High-Flux and Anti-Fouling Membrane Distillation Membrane with VOC Capture Ability Enabled by ZIF-8

Corresponding Author: Professor Bo Wang

This file contains all reviewer reports in order by version, followed by all author rebuttals in order by version.

Figure R1. (a) PXRD patterns of ZnO, pristine ZIF-8-1, and ZIF-8-1 after 10 days of water immersion. (b) SEM image of pristine ZIF-8-1. (c) SEM image of ZIF-8-1 after 10 days of water immersion.

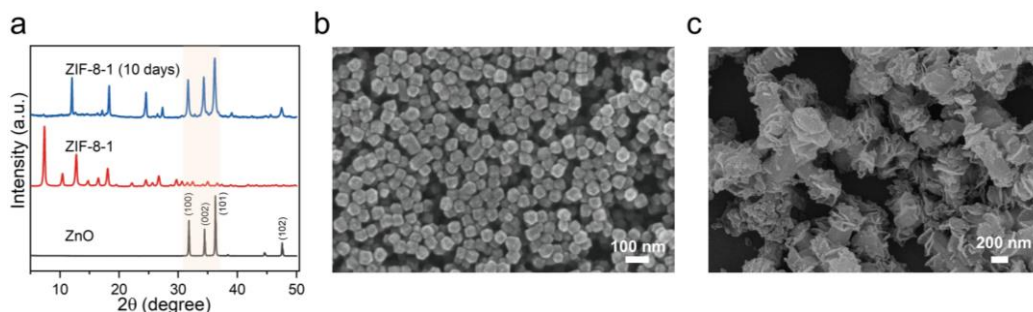
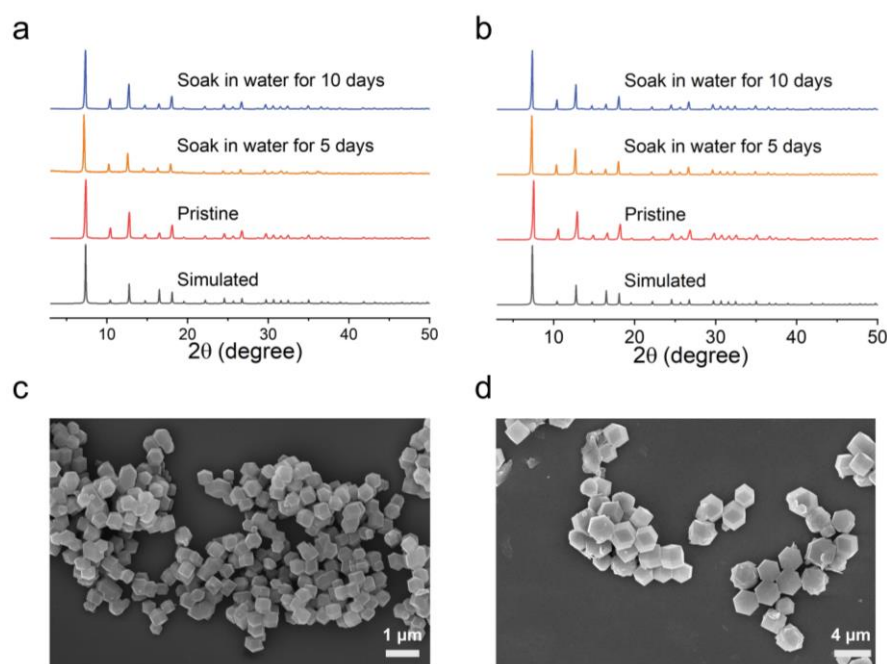
1. *Regarding the structural instability of ZIFs, the authors solely relied on ICP analysis to speculate the presence of defects and framework collapse, but lacked direct characterization evidence to substantiate these claims.*

Our previous experiments have shown that the stability of ZIF-8 strongly depends on the synthesis method. Specifically, ZIF-8-2 and ZIF-8-3, which we used in MD membranes, exhibited good structural stability, whereas ZIF-8-1 demonstrated inferior stability.

To provide direct evidence of structural changes, we performed PXRD and SEM analyses of ZIF-8-1 after immersion in water at 70 °C for 10 days. The PXRD patterns showed distinct diffraction peaks corresponding to the (100), (002), (101), and (102) planes of ZnO, while SEM images revealed pronounced morphological changes (Figure R1). In contrast, the PXRD and SEM profiles of ZIF-8-2 and ZIF-8-3 remained largely unchanged under the same conditions (Figure R2).

Compared with ZIF-8-2 and ZIF-8-3, ZIF-8-1 exhibited a significantly lower N/Zn ratio (3.67) than the theoretical value of 4, as revealed by elemental analysis and ICP measurements, indicating a higher density of coordination defects. In addition, its smaller particle size (~50 nm) leads to an increased surface area-to-volume ratio, further contributing to the formation of surface defects. These defects promote the competitive coordination of water molecules with Zn^{2+} and protonation of terminal 2-methylimidazole ligands, weakening Zn–N bonds. As a result, Zn^{2+} is released from the framework, and the supernatant pH increases from 7.4 to 8.9 over 10 days. Meanwhile, Zn^{2+} reacts with OH^- to form ZnO precipitates (*Chem. Commun.*, 2013, 49, 9140–9142; *J. Membr. Sci.*, 2015, 485, 103–111).

Fig. R1 Comparison of normalized water flux (LMH/bar) and salt rejection between the ZIF-8 PE MMM-92%-FDTS membrane and reported VMD membranes in literature.

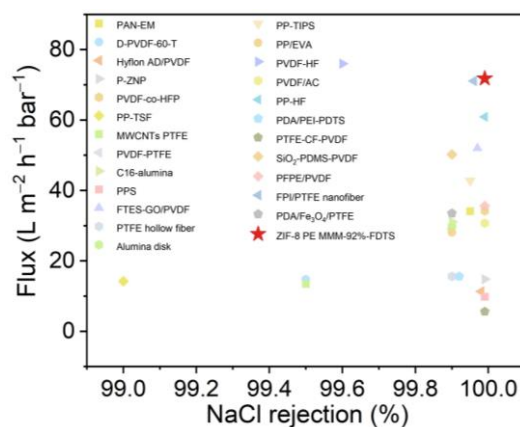
As this work does not reduce energy consumption of MD, the high flux seems to be one novelty. However, it is not accurate to claim high flux of 62 LMH in the abstract. To compare with other membranes, the flux needs to be normalized by the driving force. Therefore, LMH/bar needs to be reported rather than absolute value of flux. For the membranes in this work, ~60 LMH flux was achieved by a feed-side temperature of 70 °C, and a vacuum level of 85 kPa. This seems to be not a very high flux. For commercial MD membranes, the water flux is able to reach ~30 LMH at a temperature difference of 40 °C with ambient pressure. The authors need to look at the literature on the water permeability of MD under vacuum to justify that the water flux of their membrane is indeed better than commercial membranes.

As requested, we normalized our flux to transmembrane pressure and compared it with values reported in the literature. The resulting value was 71.8 LMH/bar, which ranks among the best reported for both polymeric and mixed matrix membranes used in VMD (Fig. R1). This value is significantly higher than those of commercial membranes, whether from published data (e.g., Immobilon-PS^Q PVDF, 19.7 LMH/bar [ACS Appl. Mater. Interfaces, 2018, 10, 13452]; VALQUA PTFE, 33.5 LMH/bar [Sep. Purif. Technol., 2023, 313, 123465]) or from our own tests on commercial membranes (e.g., ISEQ00010 PVDF, 26 LMH/bar).

Fig. R1 | (a) PXRD patterns of ZnO, pristine ZIF-8-1, and ZIF-8-1 after 10 days of water immersion. (b) SEM image of pristine ZIF-8-1. (c) SEM image of ZIF-8-1 after 10 days of water immersion.

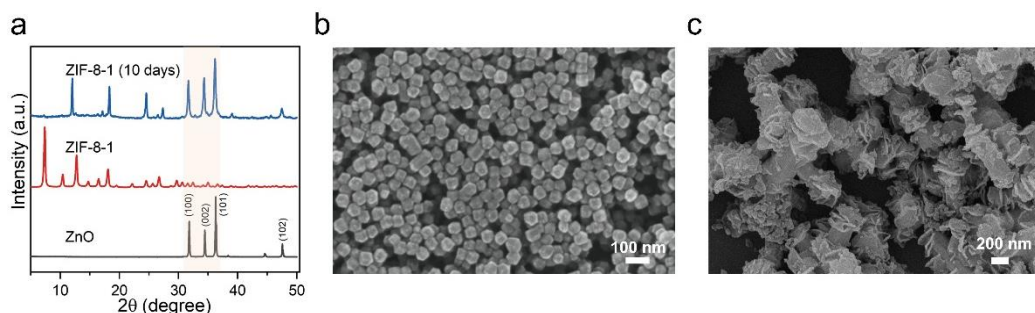
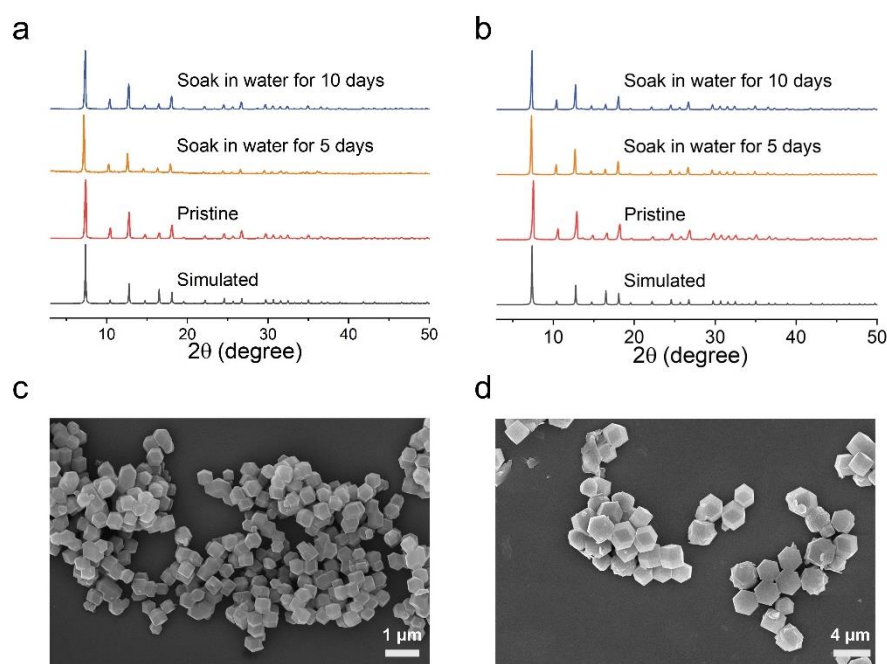
1. *Regarding the structural instability of ZIFs, the authors solely relied on ICP analysis to speculate the presence of defects and framework collapse, but lacked direct characterization evidence to substantiate these claims.*

Our previous experiments have shown that the stability of ZIF-8 strongly depends on the synthesis method. Specifically, ZIF-8-2 and ZIF-8-3, which we used in MD membranes, exhibited good structural stability, whereas ZIF-8-1 demonstrated inferior stability.

To provide direct evidence of structural changes, we performed PXRD and SEM analyses of ZIF-8-1 after immersion in water at 70 °C for 10 days. The PXRD patterns showed distinct diffraction peaks corresponding to the (100), (002), (101), and (102) planes of ZnO, while SEM images revealed pronounced morphological changes (Fig. R1). In contrast, the PXRD and SEM profiles of ZIF-8-2 and ZIF-8-3 remained largely unchanged under the same conditions (Fig. R2).

Compared with ZIF-8-2 and ZIF-8-3, ZIF-8-1 exhibited a significantly lower N/Zn ratio (3.67) than the theoretical value of 4, as revealed by elemental analysis and ICP measurements, indicating a higher density of coordination defects. In addition, its smaller particle size (~50 nm) leads to an increased surface area-to-volume ratio, further contributing to the formation of surface defects. These defects promote the competitive coordination of water molecules with Zn^{2+} and protonation of terminal 2-methylimidazole ligands, weakening Zn–N bonds. As a result, Zn^{2+} is released from the framework, and the supernatant pH increases from 7.4 to 8.9 over 10 days. Meanwhile, Zn^{2+} reacts with OH^- to form ZnO precipitates (*Chem. Commun.*, 2013, 49, 9140–9142; *J. Membr. Sci.*, 2015, 485, 103–111).

Fig. R1 | Comparison of normalized water flux (LMH/bar) and salt rejection between the ZIF-8 PE MMM-92%-FDTS membrane and reported VMD membranes in literature.

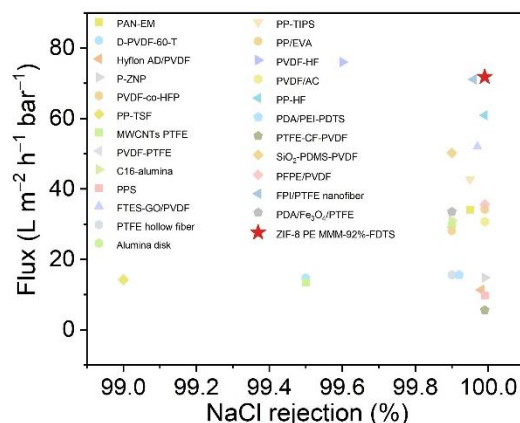
As this work does not reduce energy consumption of MD, the high flux seems to be one novelty. However, it is not accurate to claim high flux of 62 LMH in the abstract. To compare with other membranes, the flux needs to be normalized by the driving force. Therefore, LMH/bar needs to be reported rather than absolute value of flux. For the membranes in this work, ~60 LMH flux was achieved by a feed-side temperature of 70 °C, and a vacuum level of 85 kPa. This seems to be not a very high flux. For commercial MD membranes, the water flux is able to reach ~30 LMH at a temperature difference of 40 °C with ambient pressure. The authors need to look at the literature on the water permeability of MD under vacuum to justify that the water flux of their membrane is indeed better than commercial membranes.

As requested, we normalized our flux to transmembrane pressure and compared it with values reported in the literature. The resulting value was 71.8 LMH/bar, which ranks among the best reported for both polymeric and mixed matrix membranes used in VMD (Fig. R1). This value is significantly higher than those of commercial membranes, whether from published data (e.g., Immobilon-PSQ PVDF, 19.7 LMH/bar [ACS Appl. Mater. Interfaces, 2018, 10, 13452]; VALQUA PTFE, 33.5 LMH/bar [Sep. Purif. Technol., 2023, 313, 123465]) or from our own tests on commercial membranes (e.g., ISEQ00010 PVDF, 26 LMH/bar).
